ADMINISTRATIVE REPORT

| RE: Public Input Report – Valleyview South Master Plan |

Public Input Report on advancing the Valleyview South Master Plan (the Plan) for Council approval on the direction and design concept for a new neighbourhood.

B1. Land Use Plan

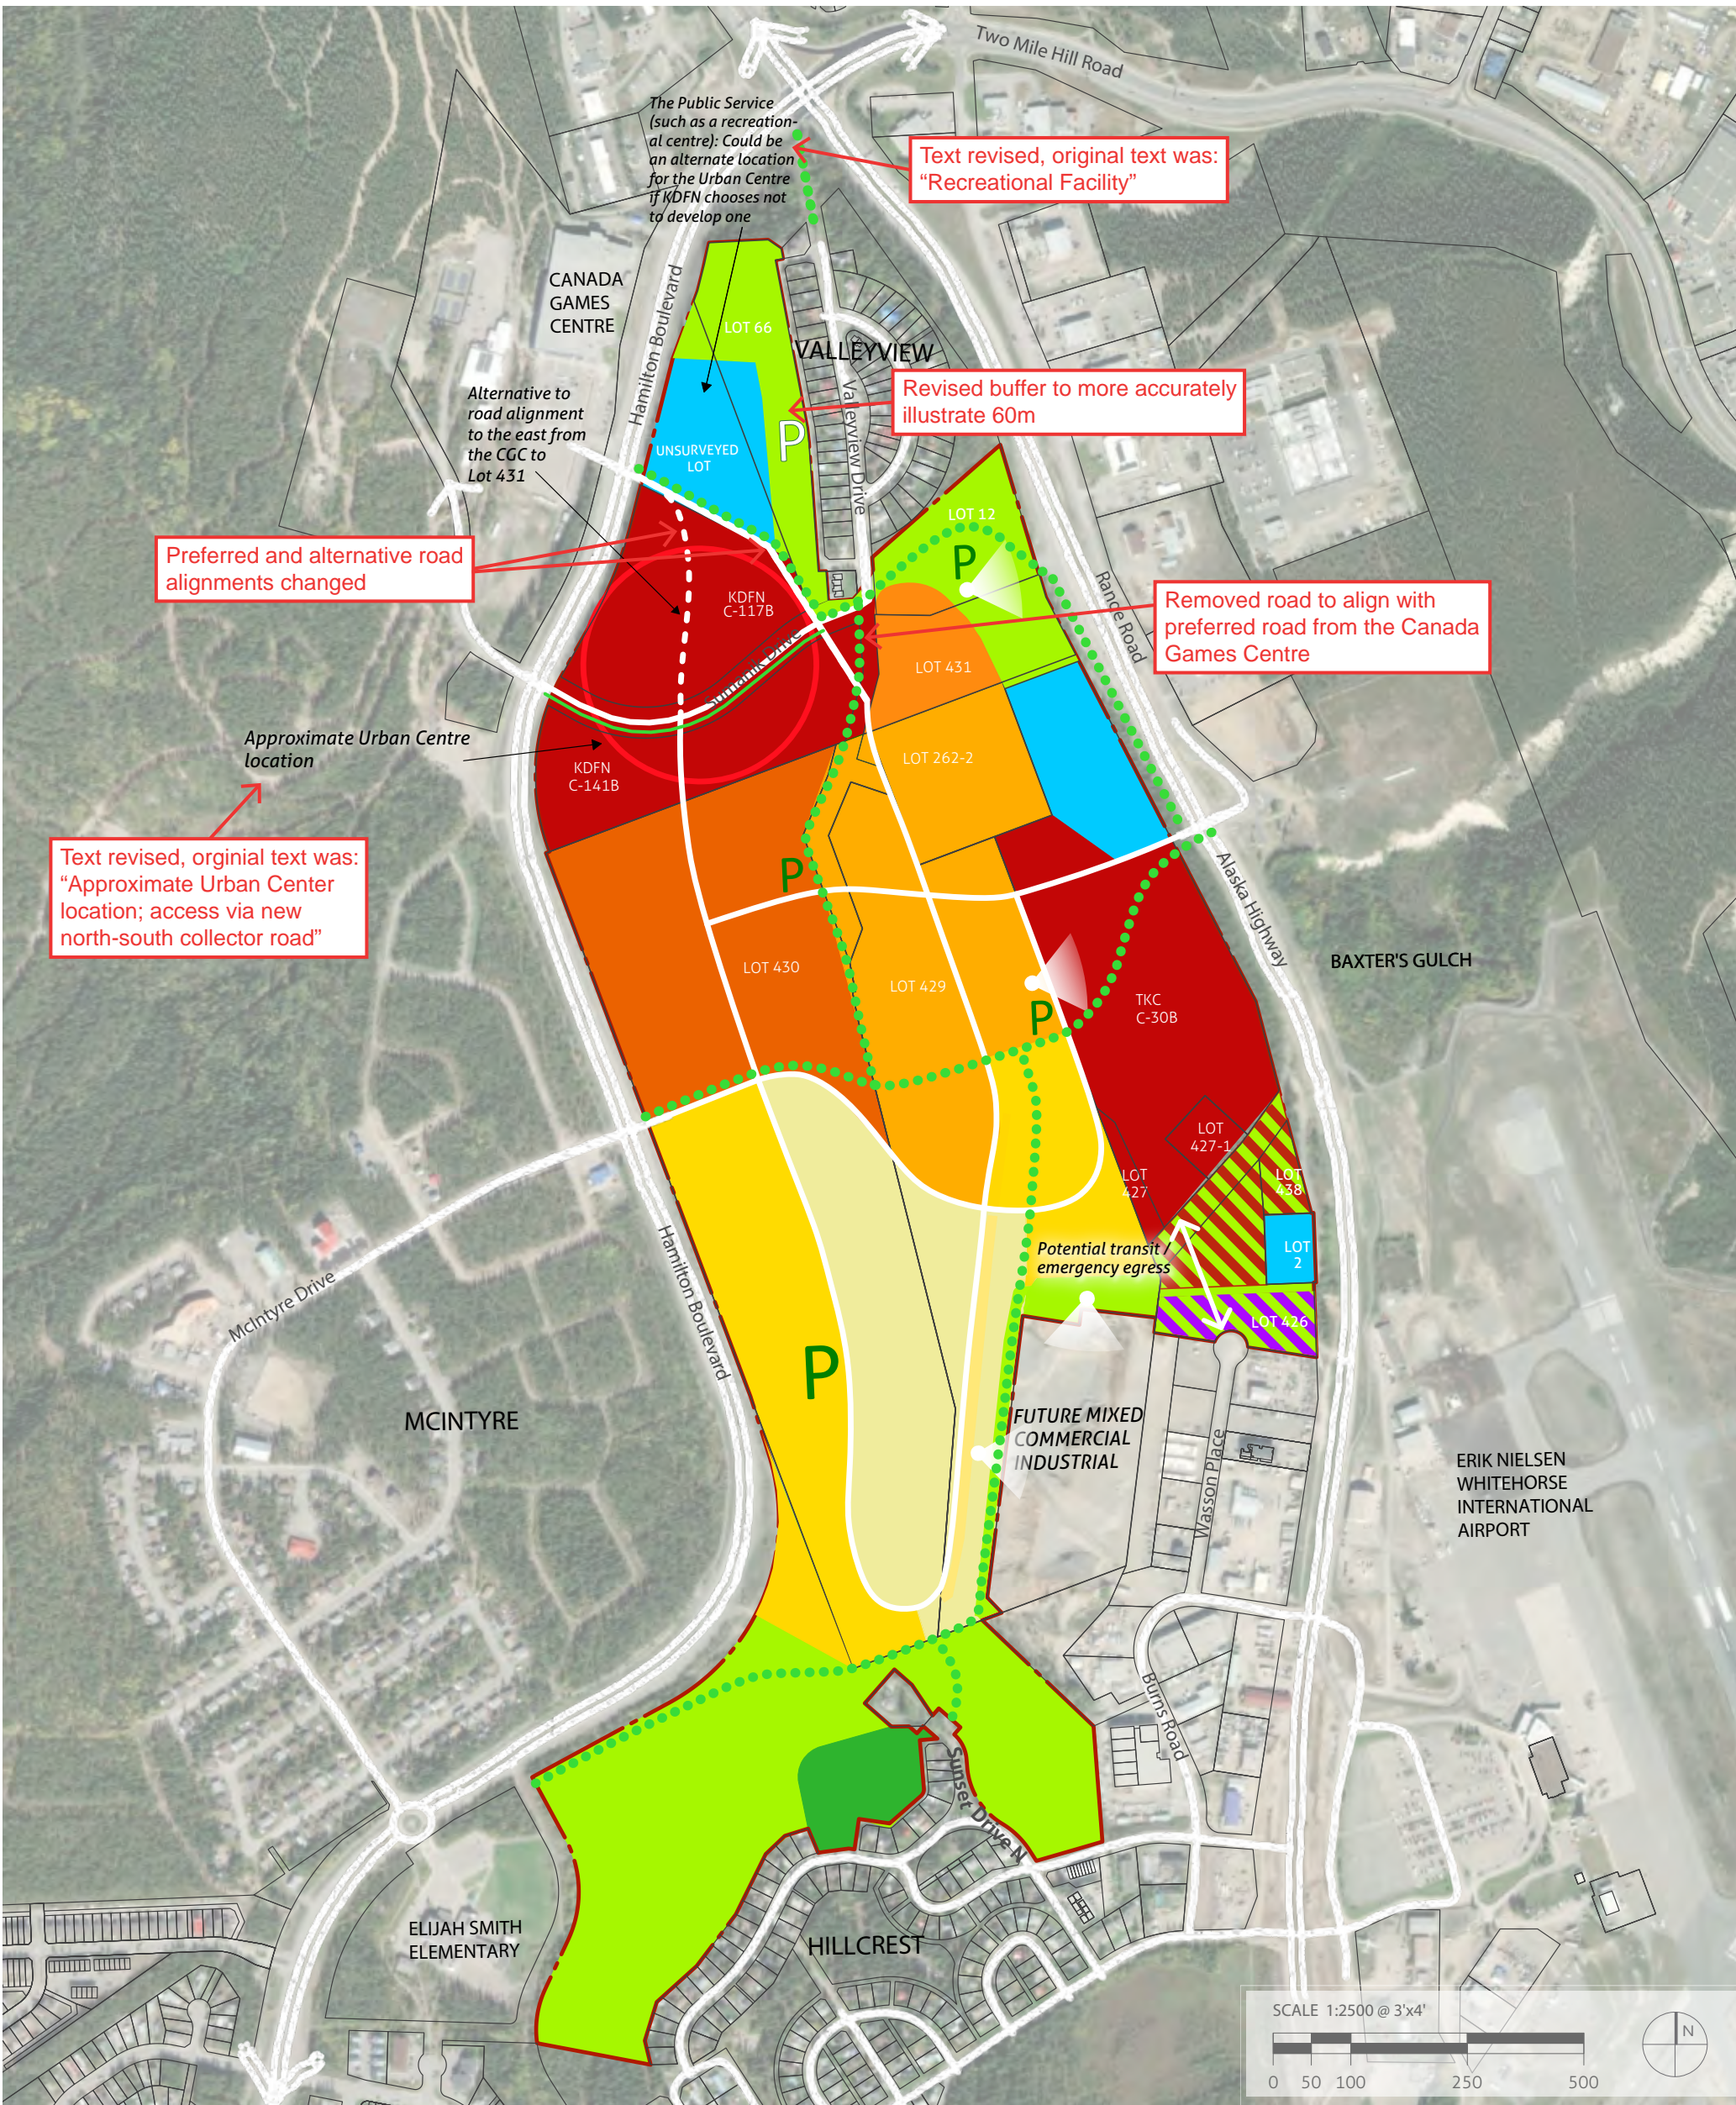
- Replace the wording under section 5.5.1 subheading Northern Area – North of Sumanik Drive with the following:
“The northern end of the planning area, bordering on Hamilton Boulevard and in proximity to the Canada Games Centre, is considered highly strategic for a future public facility, such as a recreational facility. Due to its strategic location the area is set aside for future community needs.”
- Add new bullet in Section 5.5.2 with the following:
“6. Should KDFN decide to not develop an Urban Centre on its Settlement Lands, consider the potential to develop one in this area.”
- Revise Appendix B maps B1 Land Use Plan as illustrated in Attachment 1 of this report.

Administration reviewed the conceptual buffer width illustrated on Map B1 Land Use Plan and determined it is approximately 45 m wide. Administration recommends revising the land use map to more accurately illustrate the 60 m buffer. In addition, Administration recommends that the new public/instructional facility should incorporate a 10 m vegetative setback to help mitigate adverse impacts to existing Valleyview residents. This increased setback would restrict development on approximately 0.3 ha, reducing the net area for a potential facility to approximately 1.4 ha.

- Replace policy 5.5.2.4 with the following:
 “A 10m setback should be provided to mitigate adverse impacts to Valleyview. The setback should be vegetated”.
- Revise Appendix B, Map B1 Land Use Plan to more accurately illustrate the 60 m buffer, as illustrated in Attachment 1 of this report.

B2. Transportation

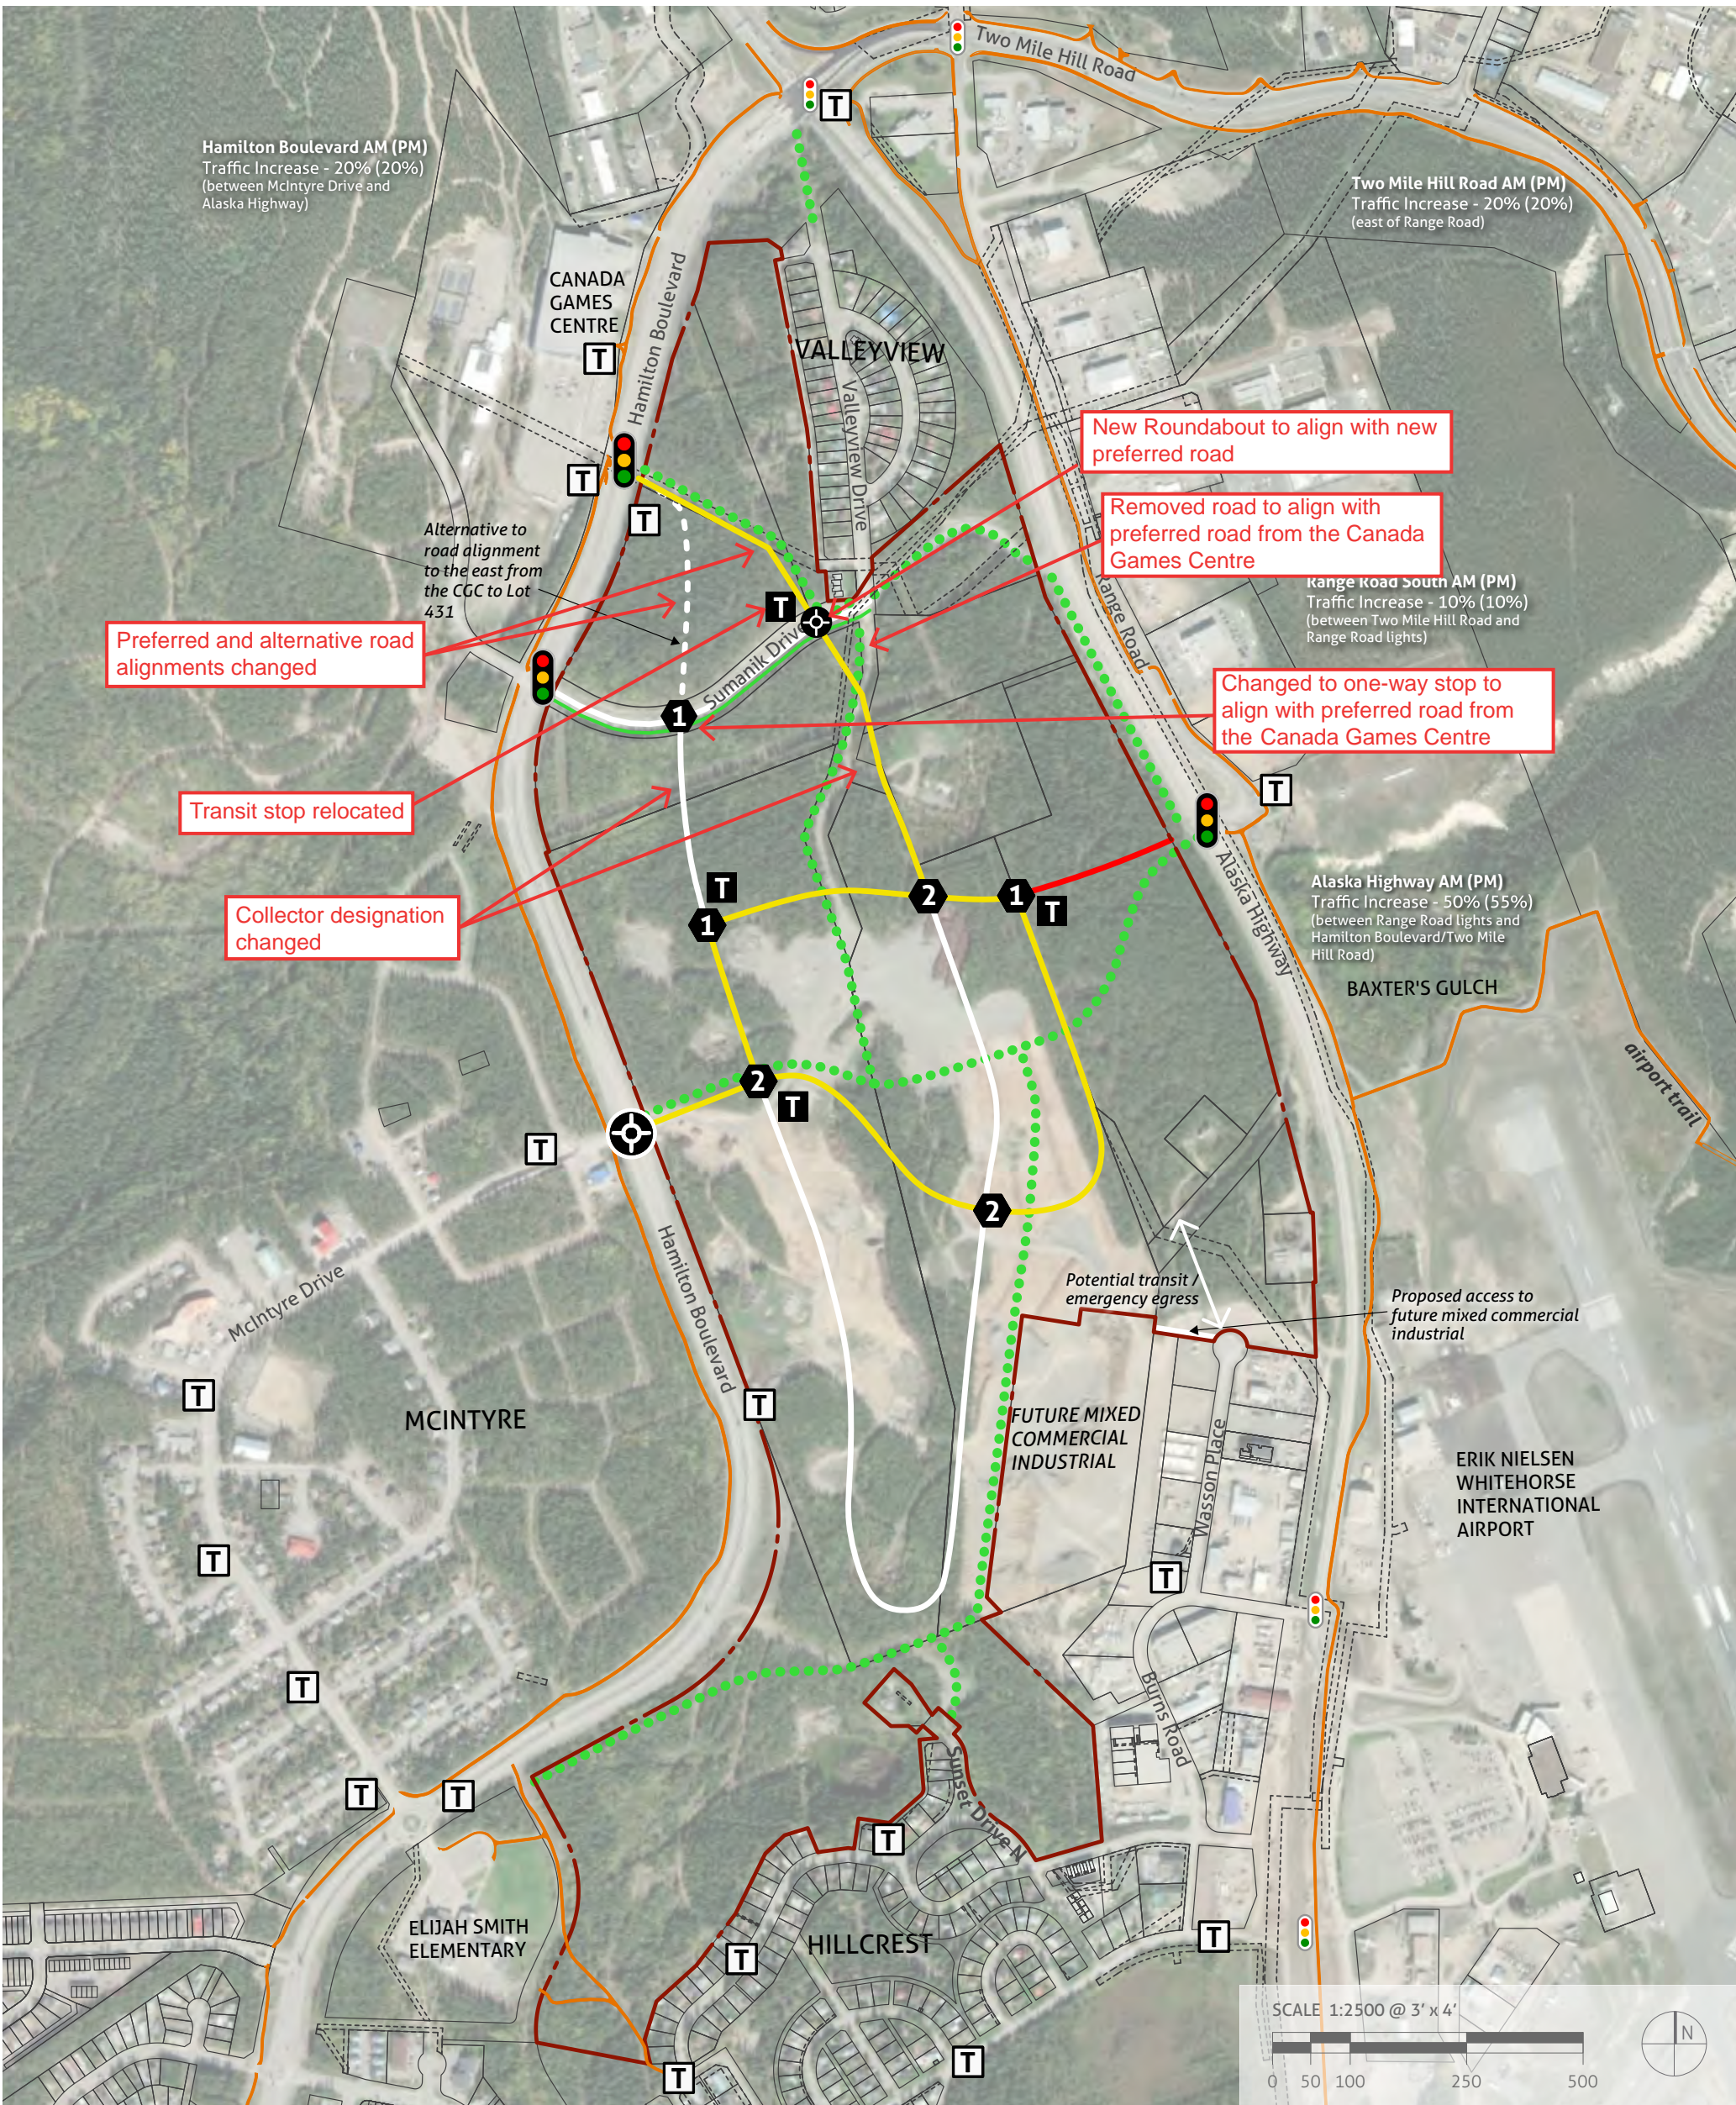
The Plan provides a conceptual road network within the planning area, including a road that could bisect KDFN's land. The Plan also indicates an alternative road connection that would avoid bisecting C-117B or C-141B. This alternative alignment is preferred by KDFN, and would provide them with greater flexibility when designing their development.

Administration also supports the alternative alignment because it provides a more direct route into the heart of the new neighbourhood for transit, emergency vehicles, and personal vehicles. It also removes a collector-type intersection within the Urban Centre which would help foster a pedestrian-oriented area. Since the Plan does not illustrate every local road, this change would not prohibit a future road bisecting the KDFN Settlement Lands, but would recommend it be a smaller local road, rather than a collector road.

- Replace policy 6.1.2.5 with the following:
“If the recommended road alignment that extends from the CGC into the Valleyview South area is determined to be unfeasible, an alternative road alignment that bisect C-117B and C-141B could be considered.”
- Revise Appendix B maps B1 Land Use Plan, B2 Transportation, and B4 Phasing Concept as illustrated in Attachment 1 of this report.
